**URGENT - Medical Device Recall  
Expression Information Portal (IP5)**

**Frozen Display Numerics and Disabled Menu Keys  
*Solution Available***

| <b>PROBLEM DESCRIPTION</b> | <p>Continuous use of the IP5 for more than 24 days, without power cycling, results in a graphical user interface (display screen) error, which causes the numeric data on the display to freeze and disables some menu keys. Waveform data displayed and audible alarms are not impacted by this problem and continue to function properly.</p> <p><i>NOTE: The IP5 is intended to be used as a secondary display control unit for the Expression MRI Patient Monitoring System and the Expression MR200 MRI Patient Monitoring System. This problem does not impact the Expression MRI Patient Monitoring System or the Expression MR200 MRI Patient Monitoring System, only the IP5.</i></p>  |

### System Restart Required within Days

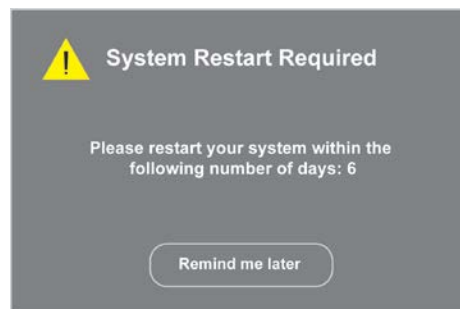
If the system has been running for 16 days without power-cycling, a dialog box with the following message will be displayed:

**Please restart your system within the following number of days: X**

X is the number of days before the system will be shut down (see example below). This dialog box will be updated and displayed every 8 hours thereafter until 21 days have elapsed (including those initial 16 days).

### System Restart Required within Minutes

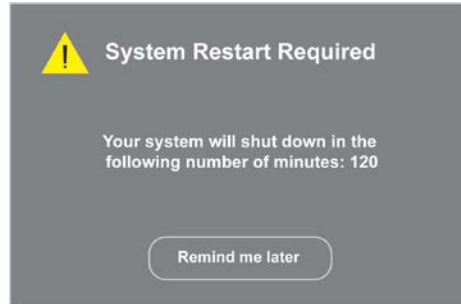
After the system has been running continuously for 21 days, a dialog box with the following message will be displayed:

**Your system will shut down in the following number of minutes: XXX**

XXX is the number of minutes before the system will be shut down (see example below). This dialog box will be updated and displayed every 15 minutes thereafter until 10 minutes before automatic shut down will occur.
